Roof Replacement at Multiple Schools

Solicitation No: DCAM-17-CS-0016

Amendment No. 3

Issued: November 17, 2016

SK - 1001

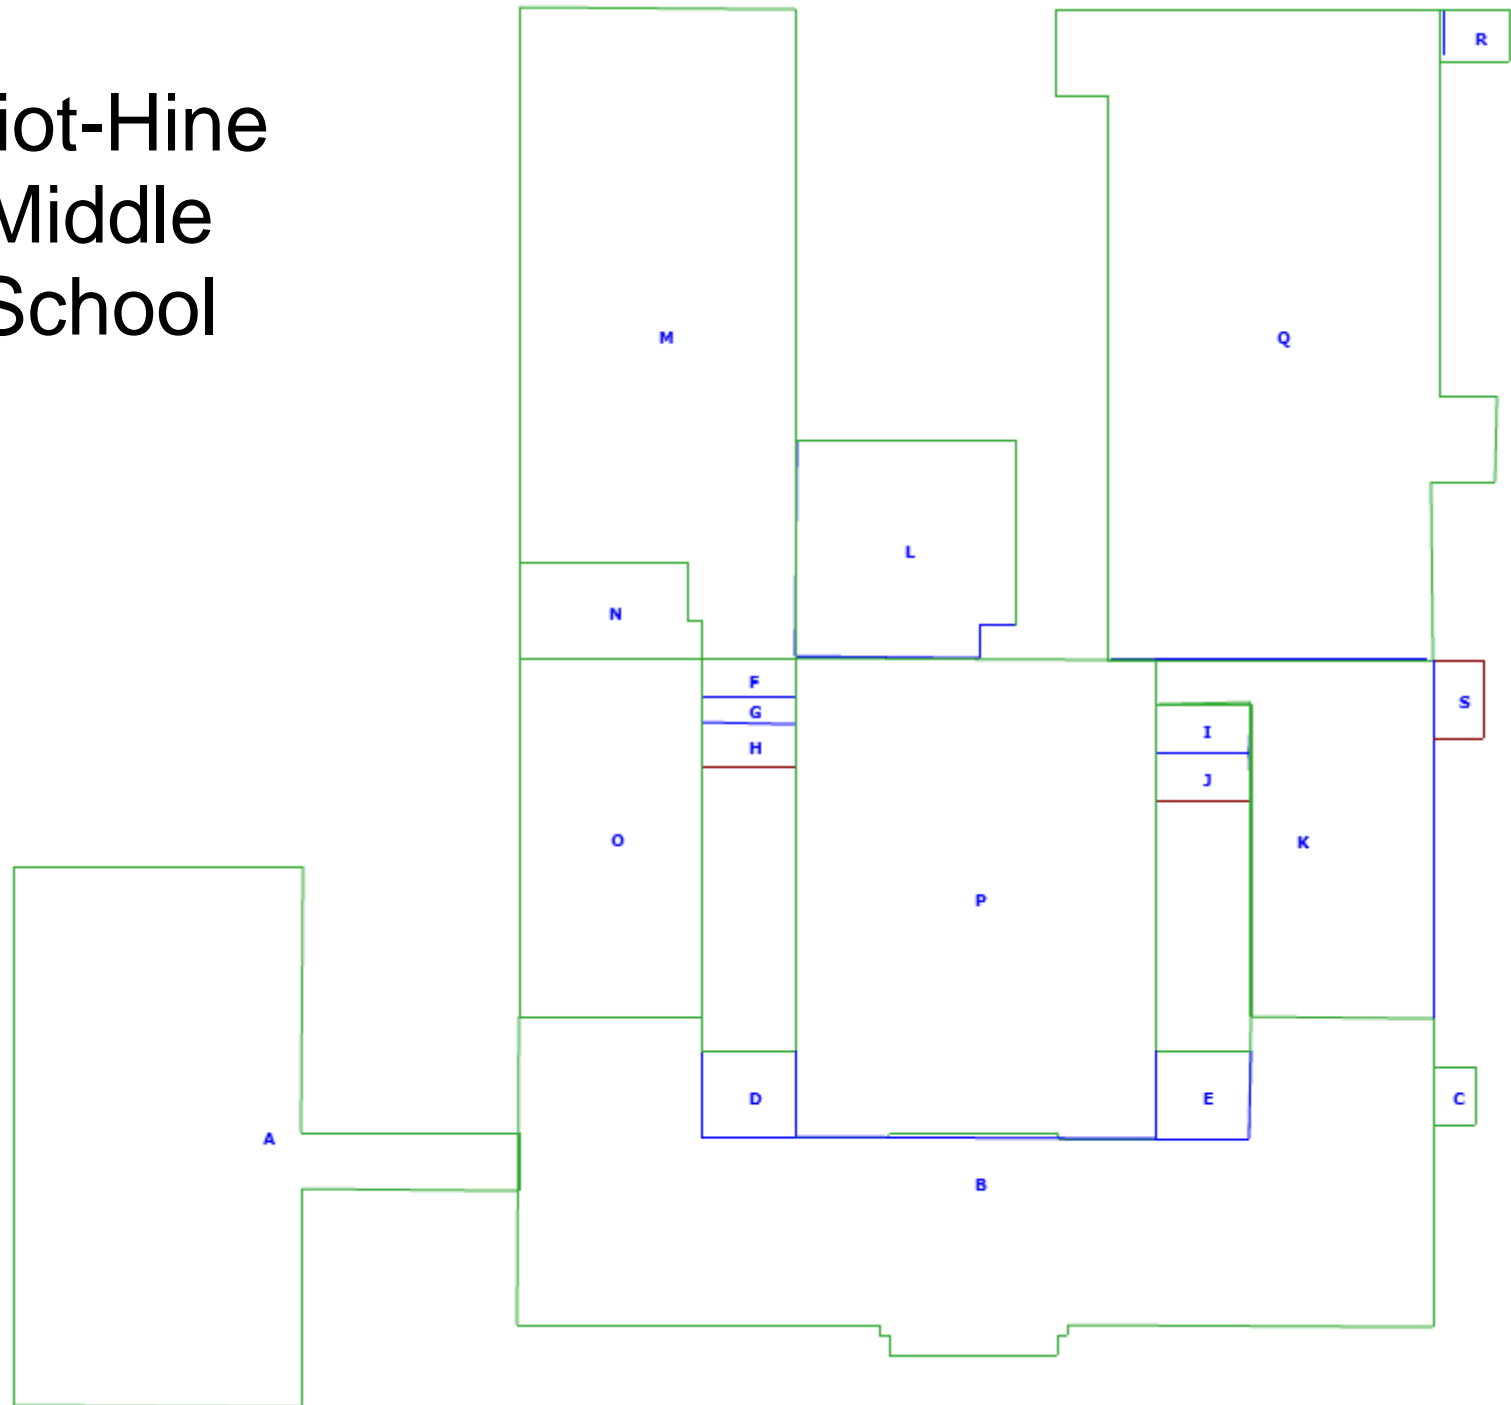
- i. Section 1.01 – Add:
 1. Remove existing roof hatches (2) and in-fill deck in accordance with the attached detail sketch.....SK - 1001
- ii. Detail D-10 – shall be installed per manufacturer’s requirements

- i. ADD: Remove and redeck all turbine vents with new insulation system installed continually over entire area per the specifications.
- ii. Clarification: Skylights: Replace all skylights in the sections where roof replacement is being completed.
- iii. Roof Section Identification Sketch to be provided in this Addendum
- iv. Details R-2.05, R-2.06 – Carpentry Section 061000– Wood blocking portrayed in the details is only a guideline to achieve the manufacturers' minimum flashing height. The quantity of nailers is the responsibility of the contractor to meet the Manufacturers minimum flashing height.
- v. Detail R2.02, R2.03 – Change .040 Prefinished Aluminum Gutter to 24 ga. Pre-finished Kynar metal

INFILL @VENTILATOR OPENINGS

1. CONTRACTOR SHALL FIELD VERIFY EXISTING CURB CONDITIONS, INCLUDING OPENING DIMENSIONS.

Concrete Deck in-fill for abandoned openings
